SUBJECT: BRUNSWICK STEAM ELECTRIC PLANT, UNITS 1 AND 2 – CORRECTION TO AMENDMENTS TO REVISE STANDBY LIQUID CONTROL SYSTEM BORON

SOLUTION STORAGE TANK VOLUME TECHNICAL SPECIFICATIONS

(EPID L-2021-LLA-0022)

Amendment No. 307 Renewed License No. DPR-71

Figure 3.1.7-1 (page 1 of 1)
Sodium Pentaborate Solution Volume
Versus Concertation Requirements

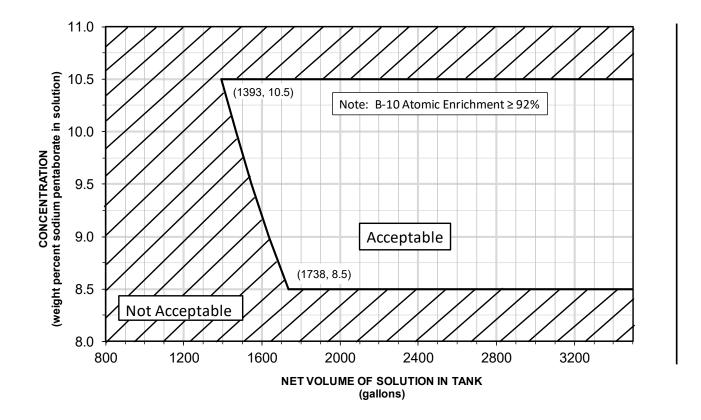
The amendments were in response to your request dated February 23, 2021 (ADAMS Accession No. ML21054A197). The amendments revised Figure 3.1.7-1, "Sodium Pentaborate Solution Volume Versus Concentration Requirements," of Technical Specification (TS) 3.1.7, "Standby Liquid Control (SLC) System," to increase the minimum boron solution storage tank volume requirements.

In order to achieve future core reload flexibility for Brunswick and to add margin to the SLC shutdown capability, the licensee plans to increase natural boron concentration from 720 ppm equivalent of natural boron to 925 ppm in the reactor coolant. As a result, the proposed change would increase the minimum boron solution storage tank volume requirements of TS Figure 3.1.7-1 by shifting the left boundary of the "Acceptable" region of TS Figure 3.1.7-1 to the right. The licensee proposes that the existing minimum volume at a concentration of 10.5 weight
